Architectural Review  
and Historic Preservation Board  
Agenda Report

File: AR 18-09

RE: Skypark Plaza Drive-Through; 2485 Notre Dame Blvd, APN 002-210-035  
Skypark Plaza Shopping Center

A5

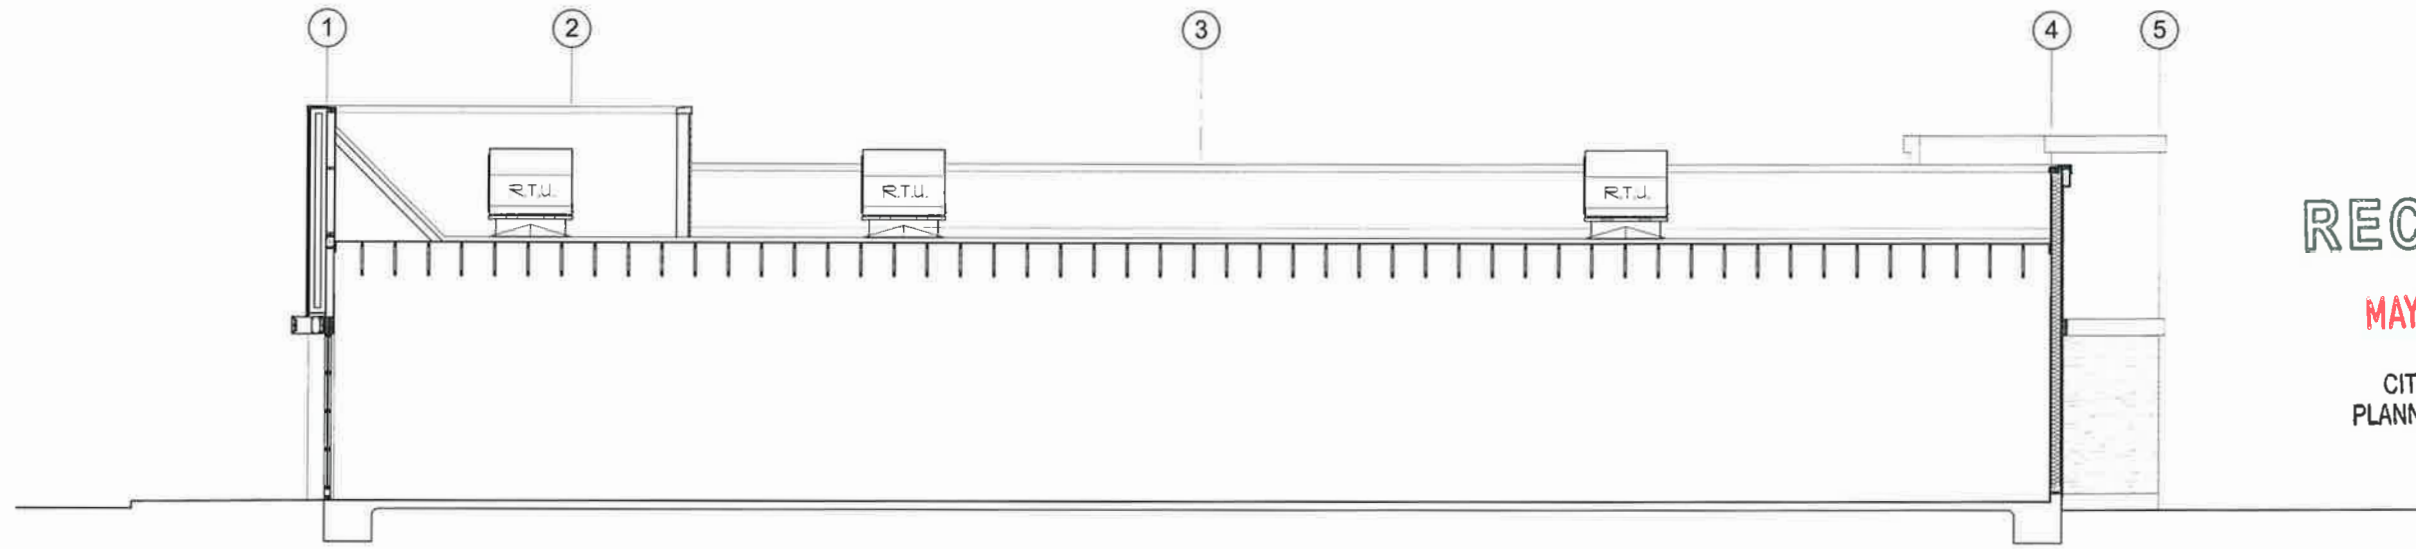
Exterior wall-mounted lighting would be black, aluminum, goose-neck wall sconces (see **Attachment D**). Parapet walls would reach 23-feet at the highest point and would provide adequate screening for roof-mounted HVAC systems (see **Attachment F**, Roof Plan). Parapet walls on the east (front) elevation include a decorative rounded cornice feature, but are omitted from the west (rear) elevation. To better meet Design Guidelines (DG) that encourage equal treatment to all four elevations of the building (DG 2.2.26), staff recommends a condition of approval (see Condition of Approval #3) that the decorative rounded cornice feature is included on all four building elevations.

3. The building plan submittal shall reflect the decorative rounded cornice feature included on all four building elevations.
4. Larger shade trees, in-lieu of crepe myrtle trees, shall be utilized near the building entry, such as Chinese pistache or evergreen pear.

SHEET TITLE:  
**CONCEPTUAL LANDSCAPE PLAN**

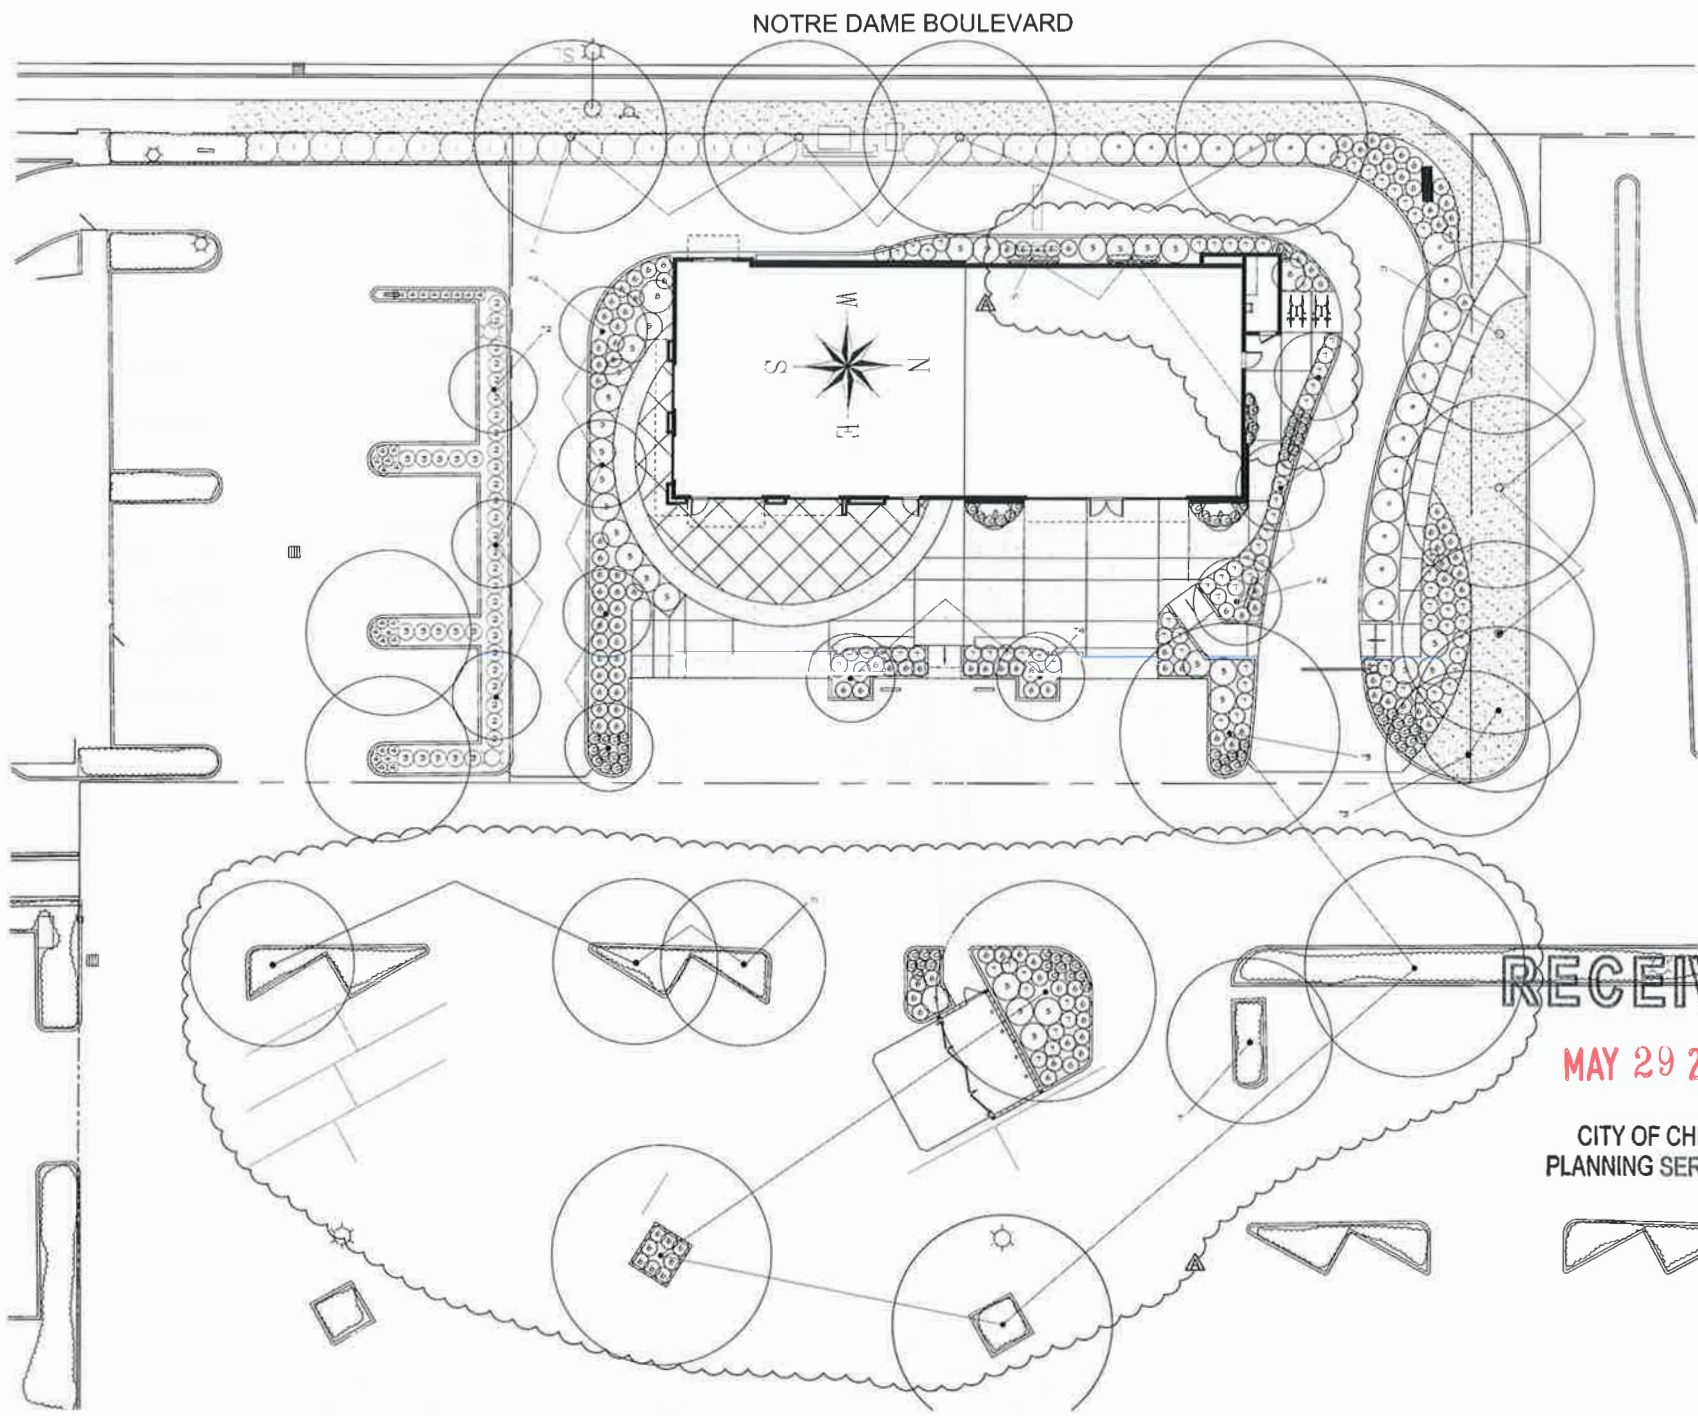
Parking lot shade is estimated to reach 50-percent at tree maturity, however, crepe myrtle trees are used to shade proposed parking spaces closest to the building entry. To ensure adequate shading, staff is recommending a condition of approval (see Condition of Approval #4) that larger shade trees be utilized near the building entry, such as Chinese pistache or evergreen pear. Additional shade trees would be installed in existing planters in the shared parking area

5. Upon building plan submittal, the applicant shall submit revised landscape/tree planting plans to the Planning Department for review. Because of poor soil conditions, the following notes shall be added to the landscape plan:

- a. Parking lot peninsular planters shall be excavated the full width (6 feet minimum) by a minimum of 12 feet in length and minimum of 30 inches deep or below the level of imported structural fill, whichever is greater.

- b. Parking lot island planters shall be excavated the full width of the planter (7 ft. by 7 ft. minimum) by a minimum of 36 inches deep or below the level of imported structural fill, whichever is greater.

- c. Shade tree planters other than the above shall be excavated 8 ft. by 8ft. by 60 inches deep. The bottom of all tree excavations shall be scarified. Backfill shall be specified by the landscape professional.
